Access Compliance Report

Public Rights-of-Way

Intersection ID: 11963	Main Street: S_GRAHAM_ST	Cross Street: W_4TH_ST	Location: E
ADA ID: 92B870A5BBE7	Ramp Type: Perp	Initial Pass/Fail: Fail	Overall Compliance: No
			Severity Score: 21.25

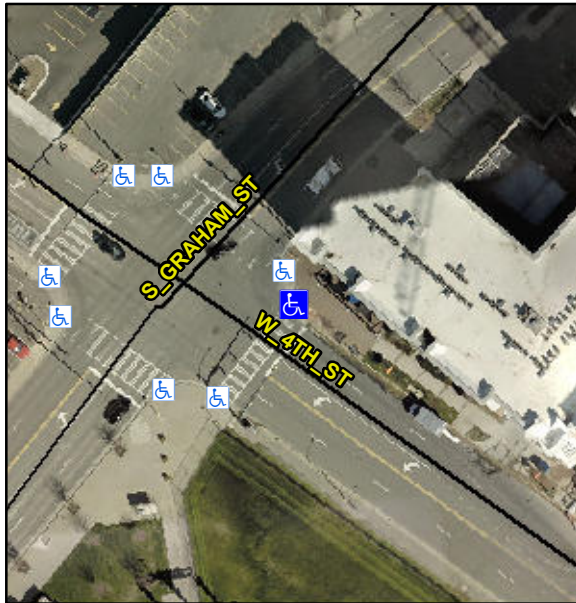
Not Found, R304.5.1, R304.2.2

Compliance	Description	Data	Compliance	Description	Data
N/A	Ramp Length (in)	72.0	No	Ramp Slope (%)	9.8
No	Ramp Width (in)	46.5	Yes	Ramp XSlope (%)	1.1
N/A	Flare Type LT	N/A	N/A	Flare Type RT	N/A
N/A	Flare Slope LT (%)	N/A	N/A	Flare Slope RT (%)	N/A
N/A	Flare Traversable LT?	N/A	N/A	Flare Traversable RT?	N/A
N/A	Landing Length (in)	N/A	N/A	DWS Provided?	N/A
N/A	Landing Width (in)	N/A	N/A	DWS Contrast?	N/A
N/A	Landing Slope (%)	N/A	N/A	DWS Length (in)	N/A
N/A	Landing X Slope (%)	N/A	N/A	DWS Full Width?	N/A
N/A	Landing Curb? (Y/N)	N/A	N/A	DWS Offset (in)	N/A
N/A	Shared Landing?	N/A			
N/A	Gutter Ponding?	N/A	N/A	Gutter Slope (%)	N/A
N/A	Gutter Lip Ht (in)	N/A	N/A	Gutter X Slope (%)	N/A
N/A	Painted X Walk1?	Yes	N/A	Painted X Walk2?	N/A
	X Walk 1 Direction	To SW		X Walk 2 Direction	N/A
N/A	X Walk 1 Width (in)	112.0	N/A	X Walk 2 Width (in)	N/A
	X Walk 1 Slope (%)	3.2		X Walk 2 Slope (%)	N/A
	X Walk 1 X Slope (%)	0.4		X Walk 2 X Slope (%)	N/A

Remove & Replace Entire Ramp.
